DCAF Bulletin

Design Construction Analysis Feedback

95-05

SUBJECT: Installation and Testing of Preapproved Underground Heat Distribution Systems

TYPICAL MANHOLE/BLDG.
WALL PENETRATION
W/END PLATE & CONDUIT ANCHOR

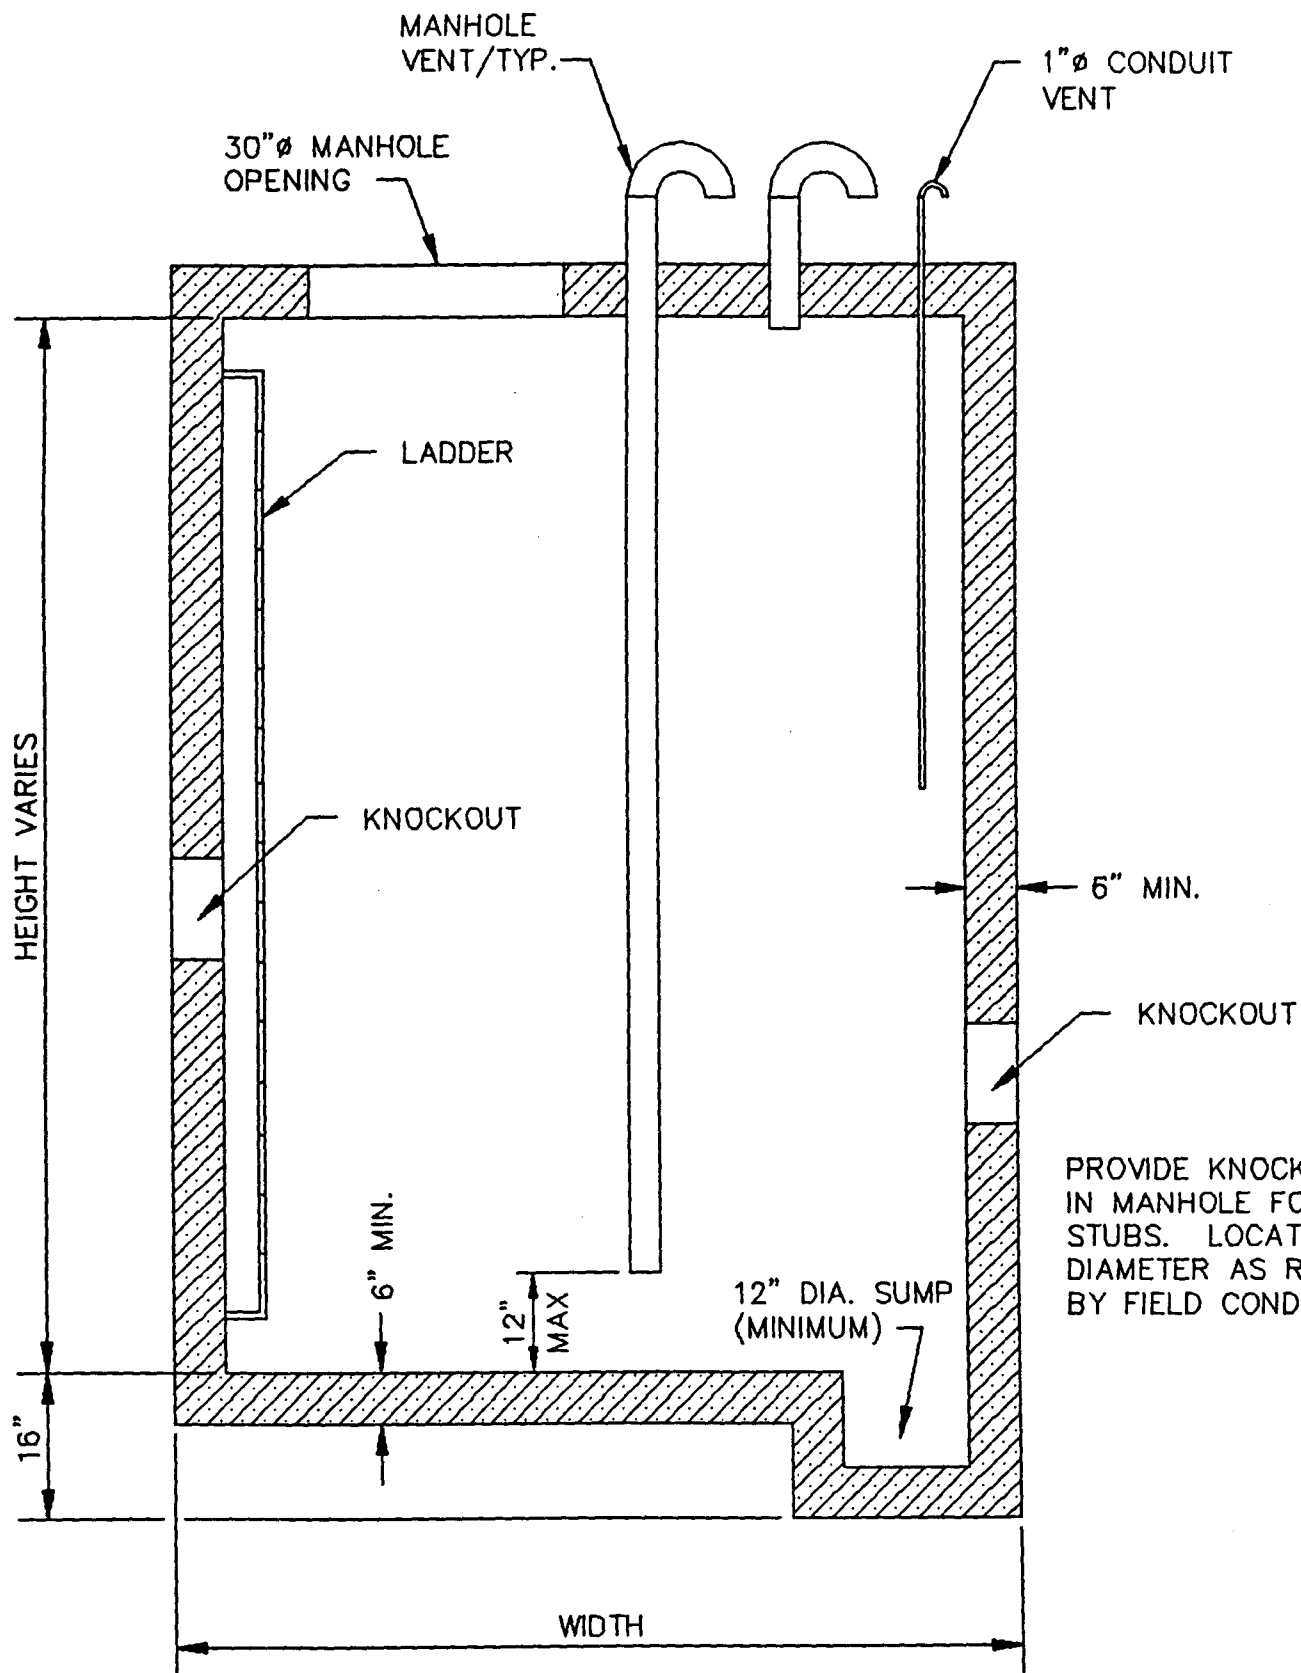
- b. Conduit drain plug was occasionally found to be missing, allowing water to enter the conduit if the manhole filled with water. Steel drain plugs rather than brass were occasionally found. In a typical manhole environment corrosion will cause steel drain plugs to be unable to be removed.

b. Conduit drain shall have a brass plug, see enclosure 1.
